DOCUMENT No. 1100141 Rev. 00

- RH POWER JUNCTION BOX -

REPLACEMENT OF IDENTIFICATION LABEL FE1549R-02

<b>LEACH</b>		<b>(F0219)</b>	
<b>RH POWER JUNCTION BOX</b>			
REF	<b>FE1549R-02</b>		
OP/NO			
N°	<b>100</b>	Cle	
OS/NI			
DATE	<b>09/07</b>	(INSP)	
<b>PILATUS part N°:974-03-38-143</b>

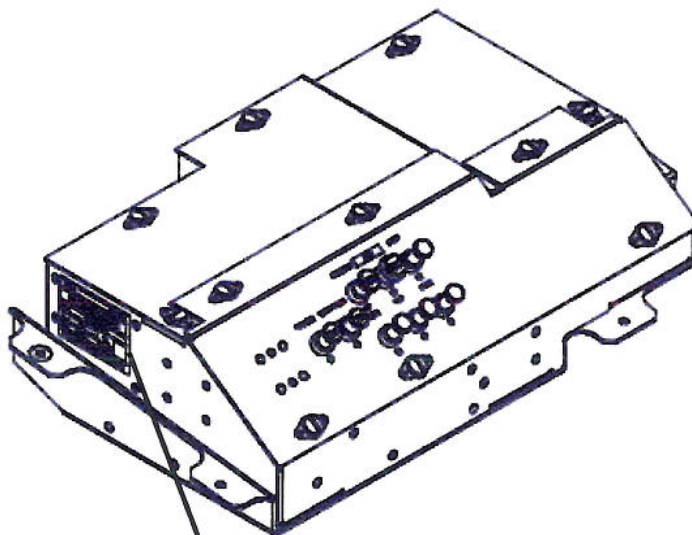
Change of identification label on RH Junction Boxes for all affected Parts due to wrong identification label.

- (1) Remove the identification label
- (2) Clean the area
- (3) Put the correct identification label with PILATUS part N°:974-03-38-143
- (4) Keep the initial Serial Number (S/N) and Date Code (D/C)

Check that the identification label is correctly installed
